ATTACHMENT TO LICENSE AMENDMENT NO. 144

TO FACILITY COMBINED LICENSE NO. NPF-92

DOCKET NO. 52-026

Figure 2.3.4-1 (Sheet 2 of 2)
Fire Protection System

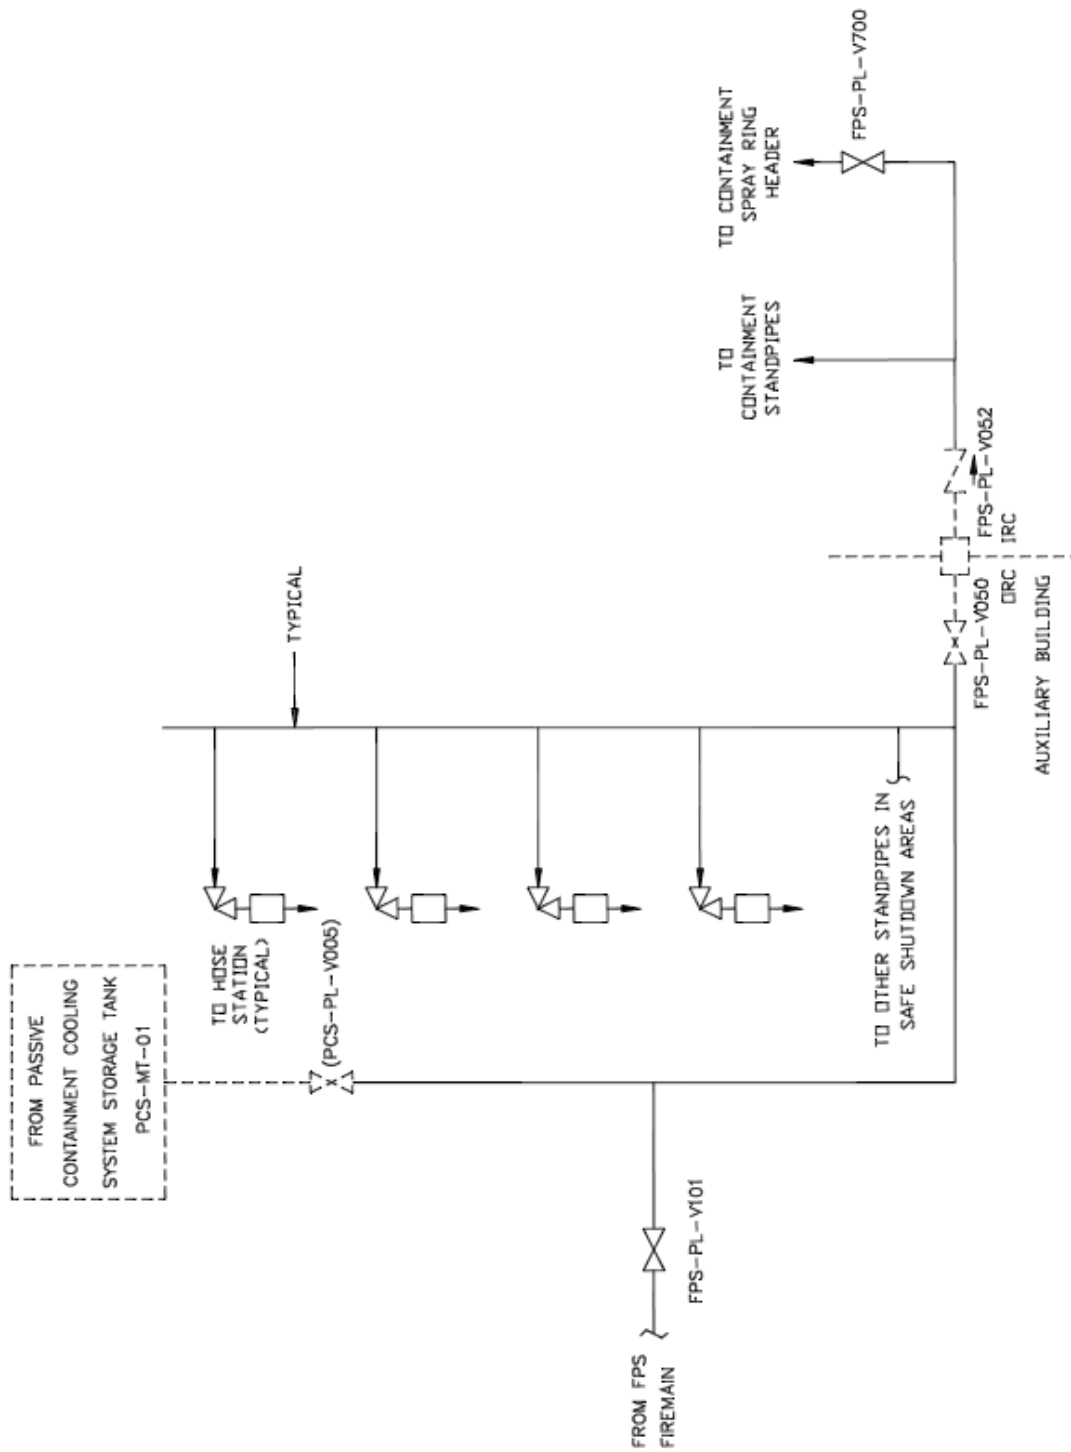
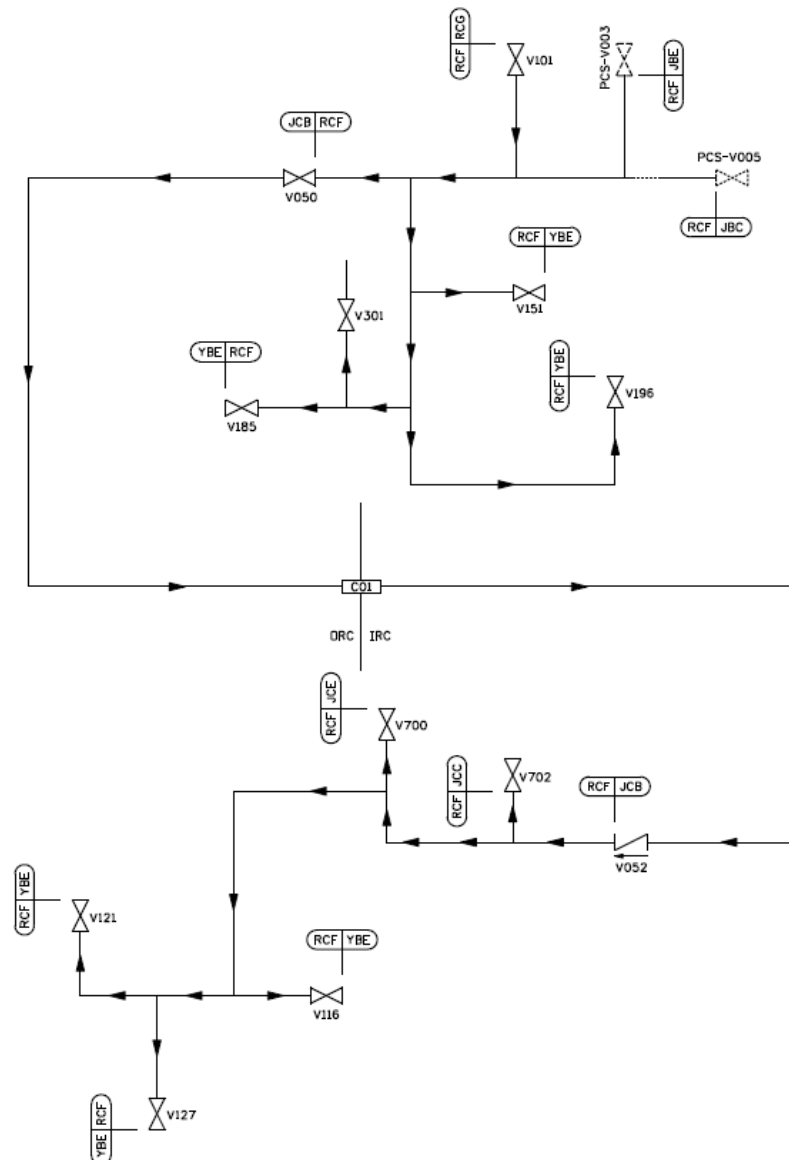
PIPING LOCATED WITHIN THE BOUNDARY VALVES OF THIS FIGURE, INCLUDING THE PIPING DOWNSTREAM OF VALVE V301, ARE DESIGNED TO REMAIN FUNCTIONAL FOLLOWING A SAFE SHUTDOWN EARTHQUAKE. THIS INCLUDES ALL RCF AND JCB CLASS FPS PIPING IN CONTAINMENT AND THE NON-RADIOLOGICAL AREA OF THE AUXILIARY BUILDING. DASHED LINES ARE RCF CLASS PCS PIPING.
